**Planning Application Reference No. 2022/2255/P
Proposed Development of Great Ormond Street Hospital, London**

We are appointed by the owners of 29 to 35, 37 to 39 (Flats 7 & 8) and 49 Great Ormond Street following concerns that the proposed development above will impact upon the daylight and sunlight receivable by their properties. The properties are all situated directly opposite the proposed new development. Please refer to below image taken from the Daylight & Sunlight Report submitted as part of the above planning application.

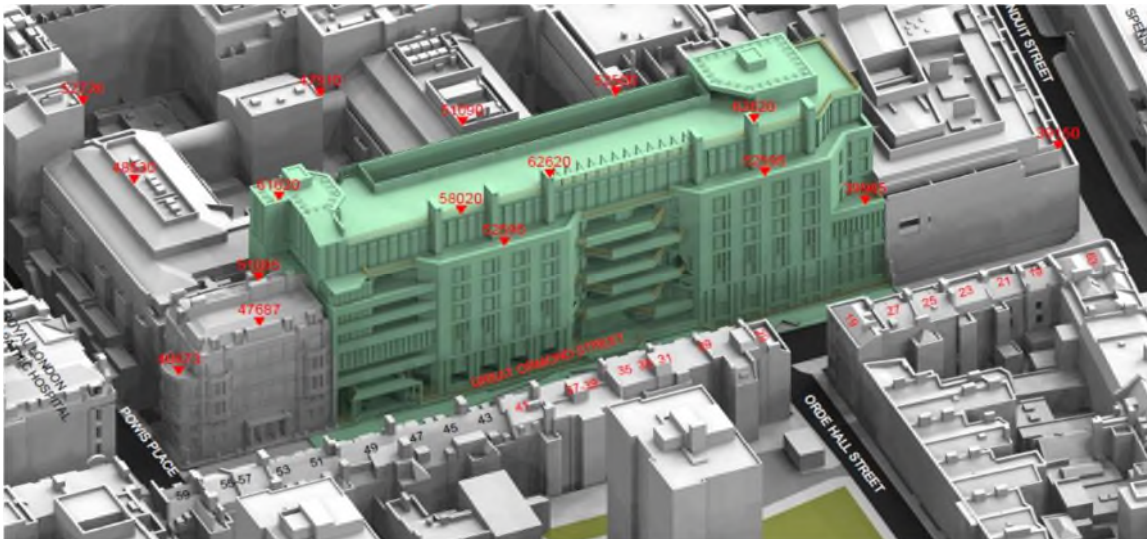
Having read through the report, the results indicate an extreme reduction of light to a number of windows and rooms at our clients' properties which breach the BRE guidelines by a significant margin. These are summarised below by property with the abbreviations of 'VSC' for Vertical Sky Component and 'DD' for Daylight Distribution used for ease of reference.

29 Great Ormond Street – All 17 habitable room windows at the property fall significantly below the VSC recommendations. All 9 habitable rooms also fall significantly below the DD recommendations. Specifically, in regard to VSC there are reductions of up to 59%, which is considerably in excess of the BRE guides 20% threshold. The DD results show losses of up to 77%, which is again considerably in excess of the BRE guide's 20% threshold.

31, 33 & 35 Great Ormond Street - All 32 habitable room windows at the property fall significantly below the VSC recommendations. All 20 habitable rooms also fall significantly below the DD recommendations. Specifically, in regard to VSC there are reductions of up to 61%, which is considerably in excess of the BRE guides 20% threshold. The DD results show losses of up to 86%, which is again considerably in excess of the BRE guide's 20% threshold.

Flat 7 - 37 to 39 Great Ormond Street – Both habitable room windows at the property fall significantly below the VSC recommendations. Both habitable rooms also fall significantly below the DD recommendations. Specifically, in regard to VSC there are reductions of up to 57%, which is considerably in excess of the BRE guides 20% threshold. The DD results show losses of up to 77%, which is again considerably in excess of the BRE guide's 20% threshold.

Flat 8 – 37 to 39 Great Ormond Street - Both habitable room windows at the property fall significantly below the VSC recommendations. Both habitable rooms also fall significantly below the DD recommendations. Specifically, in regard to VSC there are reductions of up to 57%, which is considerably in excess of the BRE guides 20% threshold. The DD results show losses of up to 77%, which is again considerably in excess of the BRE guide's 20% threshold.

49 Great Ormond Street – 13 habitable room windows at the property fall below the VSC recommendations. All 7 habitable rooms also fall significantly below the DD recommendations. Specifically, in regard to VSC there are reductions of up to 41%, which is in excess of the BRE guides 20% threshold. The DD results show losses of up to 59%, which is considerably in excess of the BRE guide's 20% threshold.

- 2) Omitted windows - Whilst a minor point, there are additional windows at the ground floor of 31 to 35 Great Ormond Street which have been omitted as it has been assumed that they serve commercial premises. My client has confirmed that in fact next to the main door are the windows that serve a bedroom and a sitting room. They should therefore be included in the daylight and sunlight report.
